Major Projects
NSW Government

Re: Proposed Ryde Hospital Redevelopment Concept & Stage 1 Submission (SUB 48633732)

Figure 1: Location of my residence to emergency hospital entrance

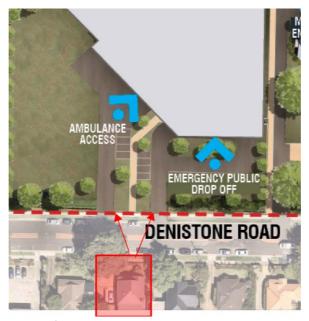
1. Driveway entry points directly opposite my residence: I note the emergency ambulance driveway/entry and public emergency drop off are directly opposite my property. Refer below, shaded red box is my house figure 1. I am worried by the amount of cars using these entrances at all times of the day and night. Has this impact to nearby houses been considered in the current layout? Currently there is no driveway entries at these locations. Also, I am worried about the additional noise impacts from ambulances and car drop off here. Two entry and exit points so close to each other seems excessive and they are concentrated directly opposite my front façade. Would the project team be able to consider these concerns in the next design iteration? Please advise.
